UNITED STATES PATENT AND TRADEMARK OFFICE

| APPLICATION NO. | FILING DATE | FIRST NAMED INVENTOR | ATTORNEY DOCKET NO. | CONFIRMATION NO. |
|-----------------|-------------|----------------------|---------------------|------------------|
| 09/456,531 | 12/08/1999 | SHIGEO OHSAKA | 991387 | 6582 |

Office Action Summary

DETAILED ACTION

Fig. 5

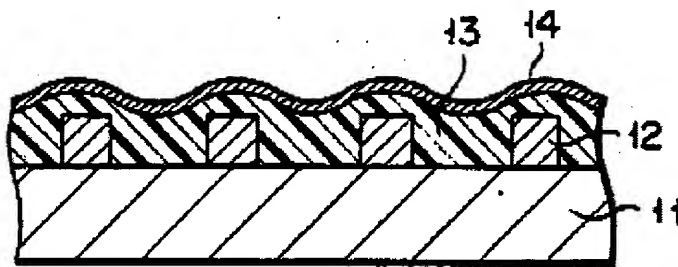
Claim 1 is rejected under 35 U.S.C. 102(b) as being anticipated by Komatsubara et al. (US 4,519,678). See esp. Fig. 5. Komatsubara discloses a structure including a bonding pad 14 formed on an insulating film 13,12 without penetrating the film, the insulating film being formed on substrate 11. The film 12,13 is not formed exactly as done in the present application, however the method of forming a device is not germane to the patentability of the device itself. The end

resulting end product is the same as that claimed. 13 is polyimide and 12 is a harder insulating layer. The portion of the polyimide between the portions 12 are interpreted as the poles, while the remaining polyimide is the burying portion. When the steps of forming the insulating film are done as in claim 1, the result is a number of poles of the insulating portion surrounded by the layer of polyimide, similar to Fig. 5 below.

Fig. 1

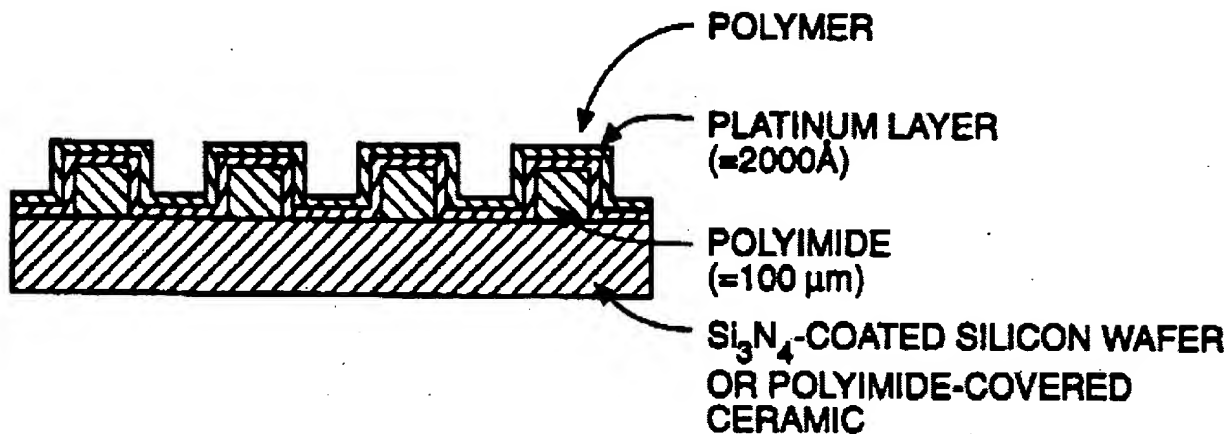
Claims 1, 19, and 20 are rejected under 35 U.S.C. 103(a) as being unpatentable over Otagawa et al. (US 5,294,504). See esp. Fig. 1.

Regarding claims 1 and 20, Otagawa discloses an electrode structure including an insulation film without penetrating the insulating film, the insulating film being formed above a base substrate (Si wafer). The insulating film comprises a number of poles of polyimide, and a first film formed on each of the side surfaces of the poles and formed of a material having a

higher hardness than polyimide. This first film is made of Pt. However, Pt is not the only layer that would work here. One skilled in would know that other, electrically conductive but insulating layers would also work. It would have been obvious to one having ordinary skill in the art at the time the invention was made to use a material such as this, since it has been held to be within the general skill of a worker in the art to select a known material on the basis of its suitability for the intended use as a matter of obvious design choice. *In re Leshin*, 125 USPQ 416.

There is a second polymer layer buried among the plurality of poles. It is not disclosed that the second burying layer is polyimide. However, it would have been obvious to one skilled in the art that they may substitute polyimide for the poly(aniline) or poly(pyrrole) polymer film by way of obvious engineering design choice.

There is not disclosed a bonding pad formed on the electrode. It is well known that electrodes typically have bonding pads thereon. It would have been obvious to one skilled in the art to include a bonding pad so that there will be a specific place to bond a wire to the electrode, as is well known.

Regarding claim 19, the first film is formed over top the poles.
